RE: RESPONSE TO COUNCIL INFORMATION REQUEST FOR A MATERIAL CHANGE OF USE FOR A MULTIPLE DWELLING (27 UNITS) UPON LAND LOCATED AT 81 YORK STREET, INDOOROOPILLY QLD 4068 – COUNCIL FILE REFERENCE A006928376.

We write in relation to the abovementioned development application and the Information Request correspondence dated 28 January 2026. Pursuant to section 13.2 of the *Development Assessment (DA) Rules* under the *Planning Act 2016*, we provide a full response to Council's Information Request below.

Figure 1: Proposed frontage amendments clouded and labelled.

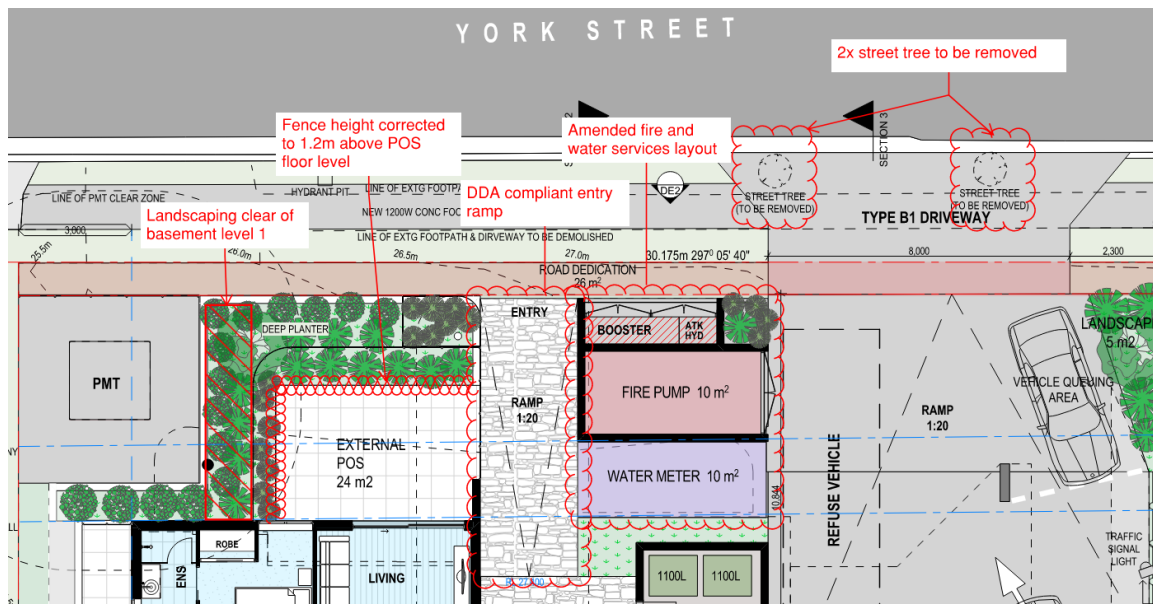
3. The site's frontage is dominated by services and boosters, vehicle access and retaining walls without deep planting, includes fencing in excess of 1.2m and 50% transparency, and has equitable access located off the driveway which does not meet PO5, PO12, PO28, PO33 and PO37 of the Multiple dwelling code. The development does not provide for an appropriate streetscape interface and includes a dominance of hardstand and service when viewed from the street. Further, the configuration of the equitable access presents safety concerns for residents and visitors of the site.

- a. Amend the design to lower the finished floor level of the entry way to the building to remove the need to provide stairs and a DDA compliant ramp.

- b. Amend the design to rotate the hydrant booster assembly to front the driveway.
 - c. Provide a maximum of 1.2m high fencing to the private open space of the ground floor unit.

- d. Consider removing areas of the basement not necessary (ie. storage areas) in order to provide deep planting and additional landscaping at the frontage.

As requested, the proposed development has been amended in direct response to Council's comments regarding the streetscape interface. The revised architectural and landscape plans implement the requested design changes, which are considered to materially improve the functionality and building presentation along the York Street frontage. Specifically:

- The pedestrian entry has been redesigned to provide a safer access arrangement, with a DDA compliant pedestrian ramp integrated into the frontage landscaping and separated from the vehicle crossover;
- The fire and water services have been reconfigured to improve functionality and integration with the frontage. Noting QFES access requirements, the hydrant booster assembly must remain oriented to the street to ensure clear and immediate emergency access. Please refer to the enclosed Building Certification Advice Letter provided by the project building certifier;
- Fencing to the ground floor private open space has been corrected to a maximum height of 1.2m and embellished with additional landscaping; and
- Basement footprint refined to permit containerised deep planting at the frontage, increasing landscaping and reducing the dominance of hardstand and services.

Collectively, these amendments improve pedestrian safety and ensure the development presents as a landscaped interface rather than a service-dominated frontage. The revised design therefore addresses Council's concerns and achieves improved compliance with the Multiple Dwelling Code.

Figure 4: Proposed section of the refuse collection bay confirming that a 3.7m vertical clearance within the designated RCV standing and manoeuvring area is provided.

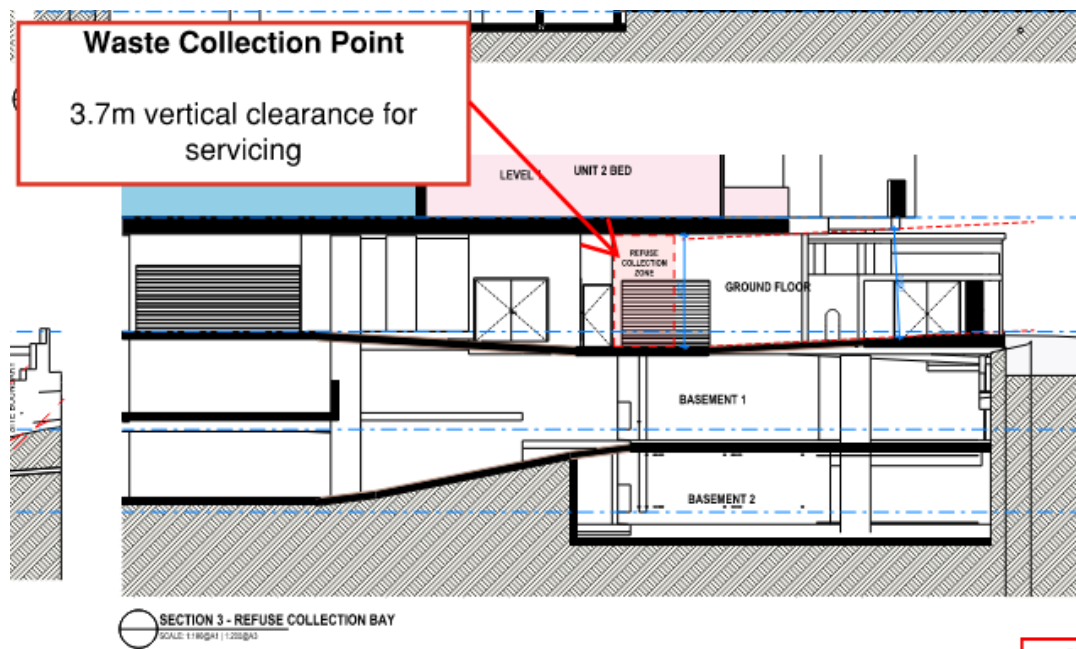
16. Insufficient vertical clearance is provided to accommodate the RCV within the proposed standing location (see DWG No SK301):

- a. In accordance with PO18 and PO19 of the TAPS code, provide amended plans which demonstrate the required vertical clearance is achieved in accordance with the TAPS PSP.
- b. Demonstrate the RCV standing locations do not impact on passing for both the proposed signal management plan and vehicles entering/exiting the ground floor parking spaces.

As per the amended Waste Management Plan and drawing number SK401 of the Amended Architectural Plans, a minimum vertical clearance of 3.7m is provided within the designated Refuse Collection Vehicle (RCV) standing and manoeuvring area.
